## Comments for Oregon Solar Energy Code

David McClelland

Energy Trust of Oregon

**Figure 5.**  
2 kW system with shading on west side of roof from a chimney.

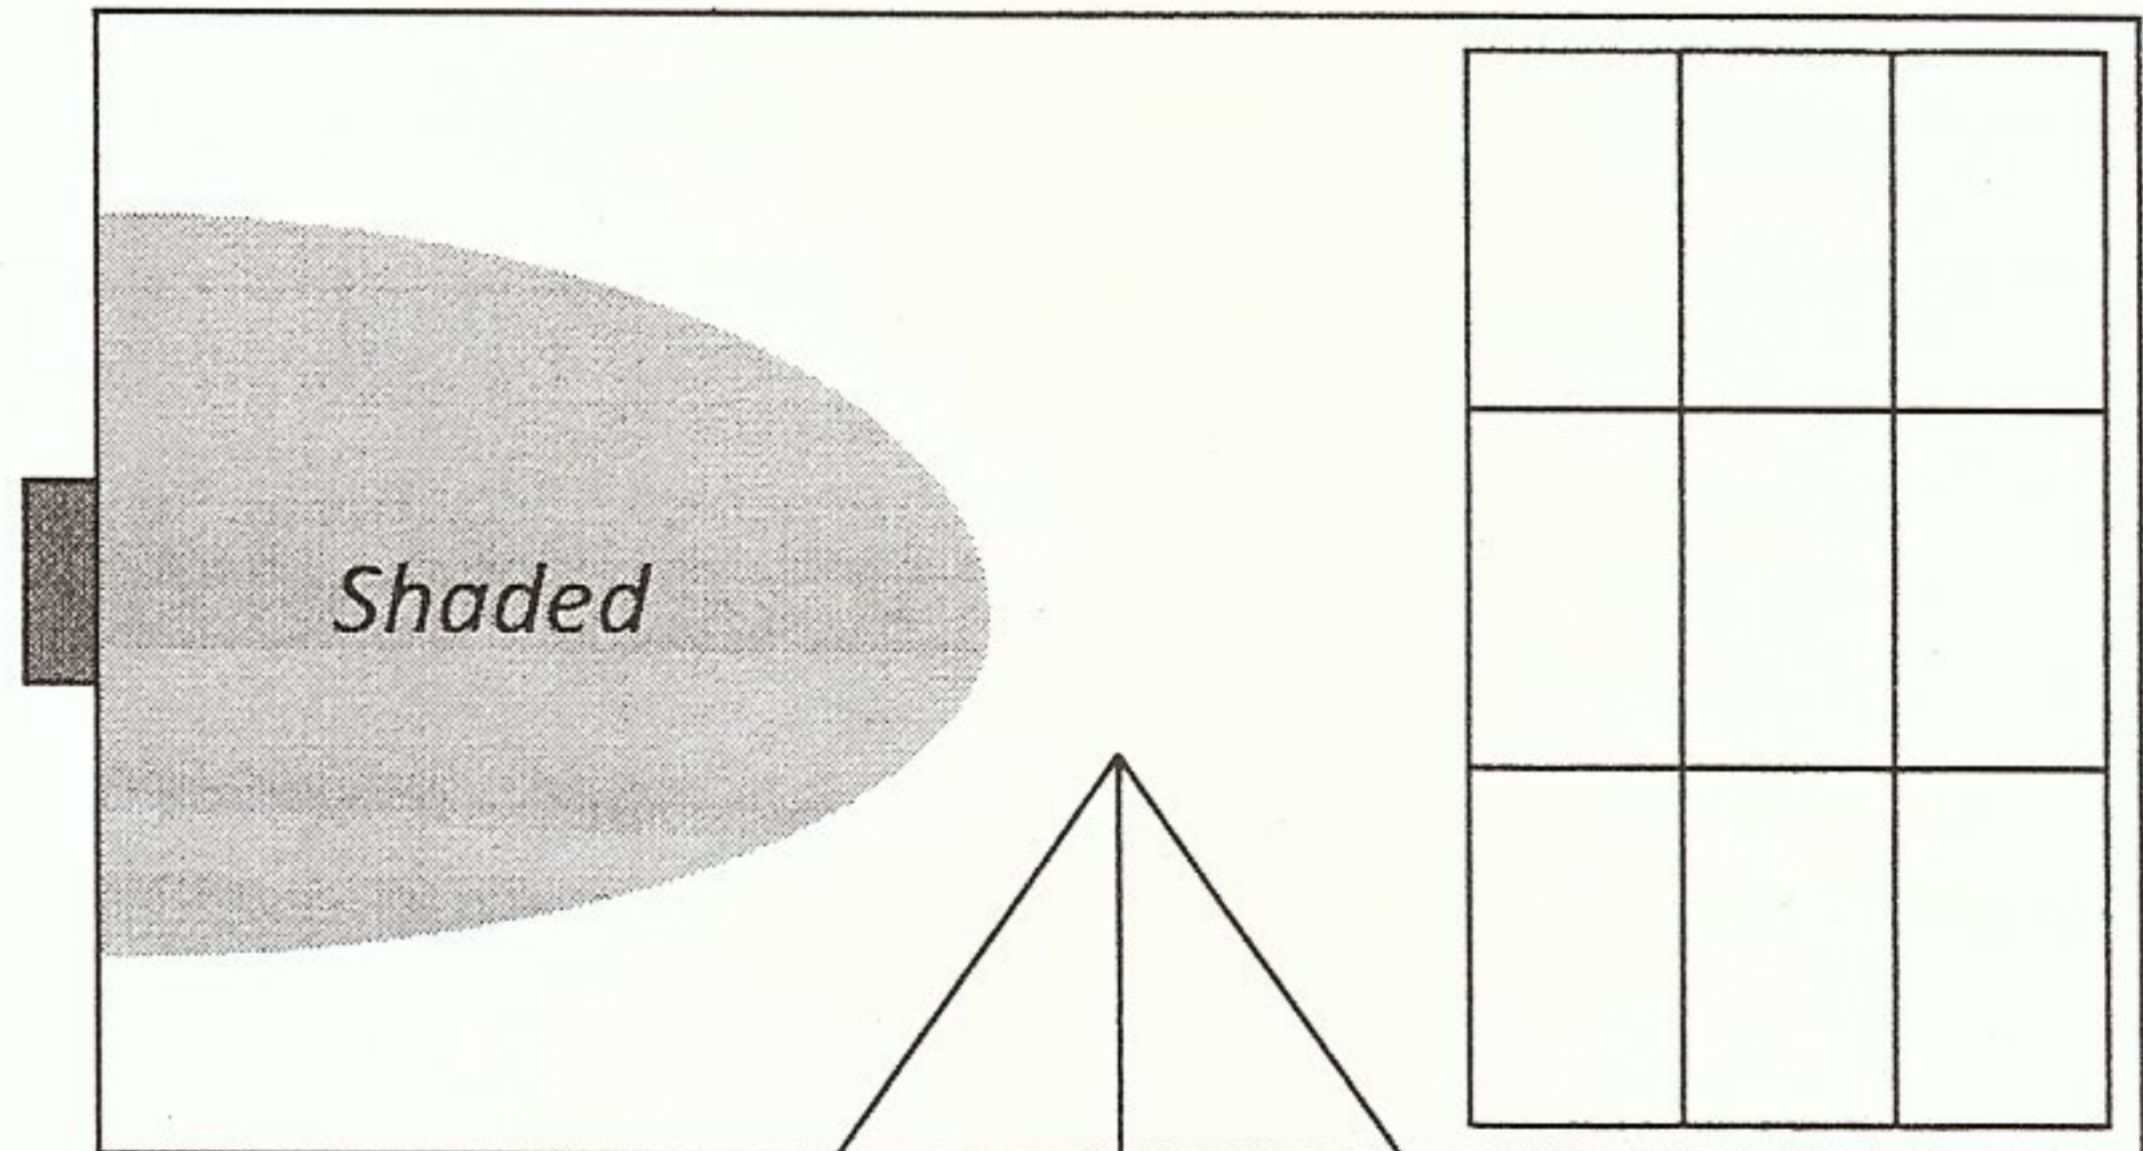
Even for small systems—where the majority of the roof remains uncovered and accessible—setbacks limit design options that allow installers to minimize shading impacts and maximize performance. Under the new feed-in tariff incentive structure, performance is critical to the customer’s payback on investment.
